AERONAUTICAL CHARTING FORUM
Charting Group
Meeting 09-01 – April 29-30, 2008

RECOMMENDATION DOCUMENT

FAA Control # 09-01-215

Subject: Reporting & Depiction of Stopway

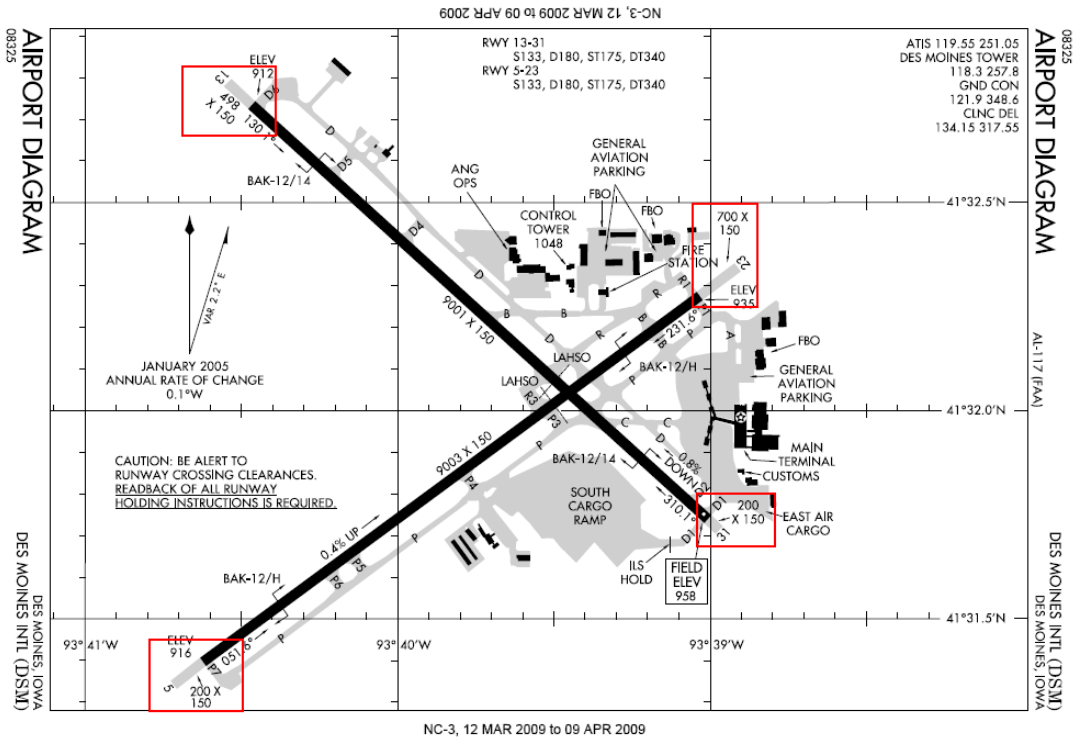
Attention is called to item 2(b)'s reference to "overruns". An overrun is a term applied strictly to military runways as defined in the AIM's Pilot/Controller Glossary:

Further, the term "overrun" is not used in AC 150/5300-13, Airport Design to describe any surface component of a runway. Therefore, the use of the term "overrun" in Order 7910.4C may be inconsistent with the stated purpose of this Order:

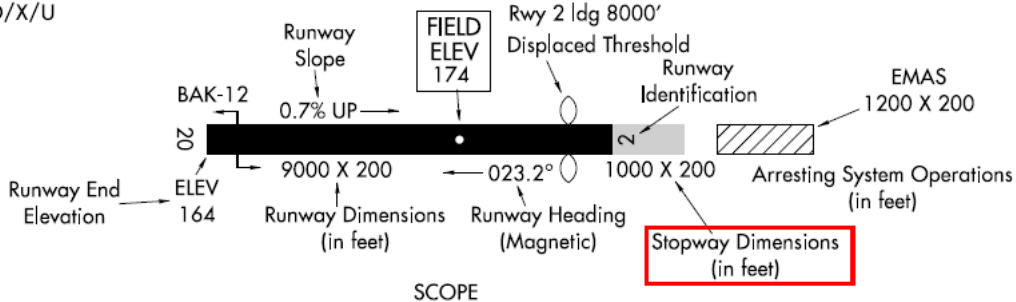
In reference to the TPP Airport Diagram Legend when a depicted area beyond the end of the runway contains dimensions, the area in question is identified as a stopway:

If the DSM A/FD entry is cross-checked against the above Airport Diagram, we find that the stopway length and associated declared distances for each runway have not been recorded as required by AC 150/5300-13 paragraph 309:

Since the introduction of this agenda item, AeroNav/NACO has modified the legend of the Terminal Procedures Publication, removing the “stopway dimensions” from the pavement extensions beyond the end of the runway. This action eliminates one source of confusion regarding whether the extension is a stopway absent corresponding published declared distances information in the AFD. This action satisfies the agenda item’s recommendation #5.

The DSM Airport Obstruction Chart (Jan 2005) was also referenced to determine the validity of the stopway designation. Excerpts from the DSM's OC chart show the areas in question depicted as blast pads:

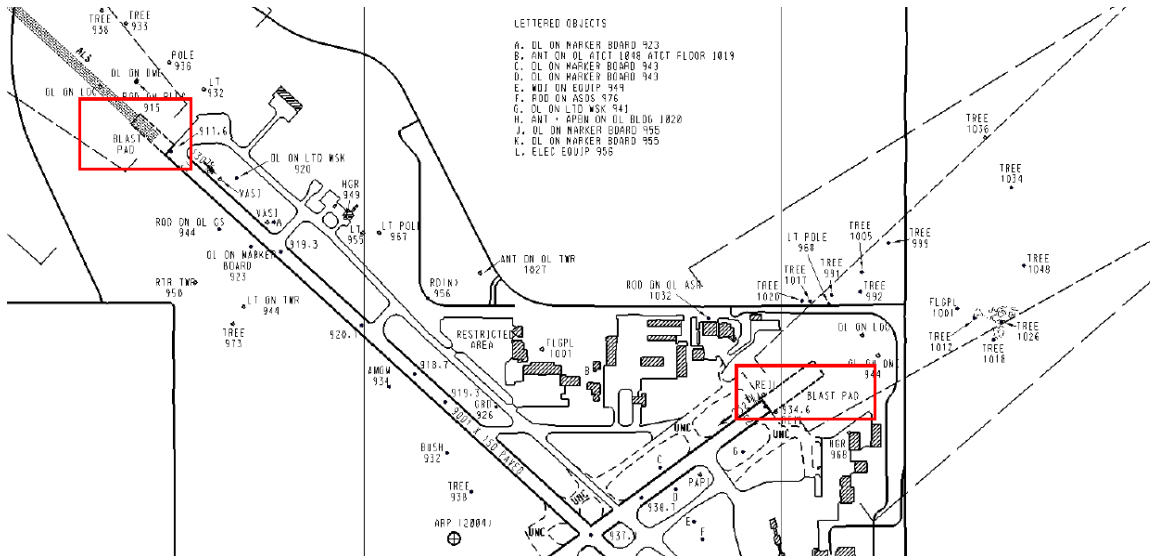
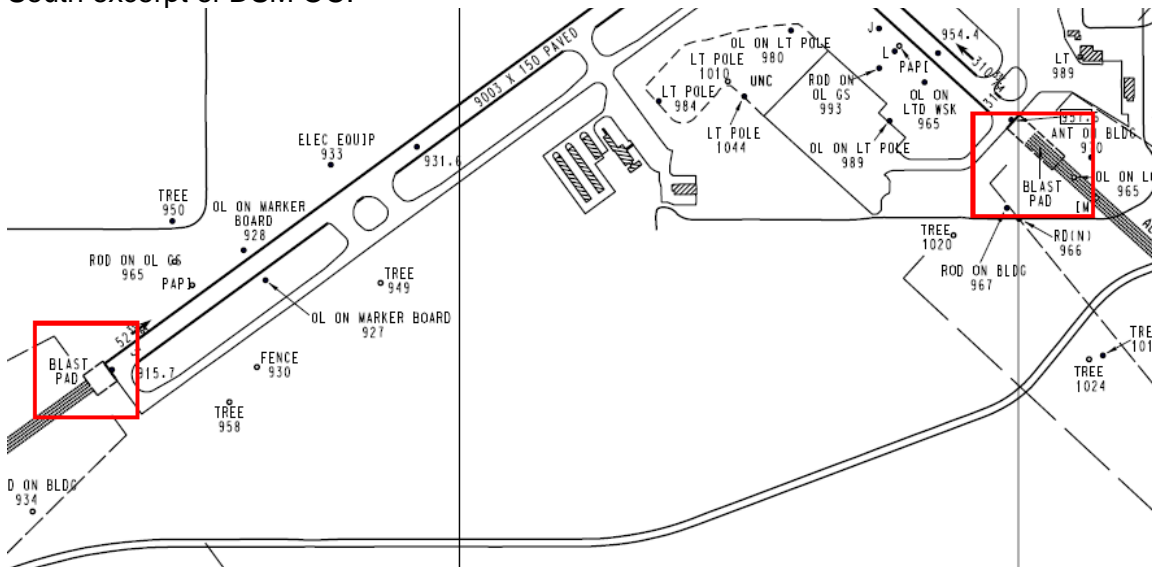
The DSM OC's depiction of these areas as blast pads is supported by the information contained in the DSM's NGS Aeronautical Data UDDF file. The first line below the runway heading element records the known status of a blast pad for that runway. For DSM's runways, the blast pad status record is as follows:

The NGS Aeronautical Data UDDF file supports the DSM OC's designation of these areas as blast pads.
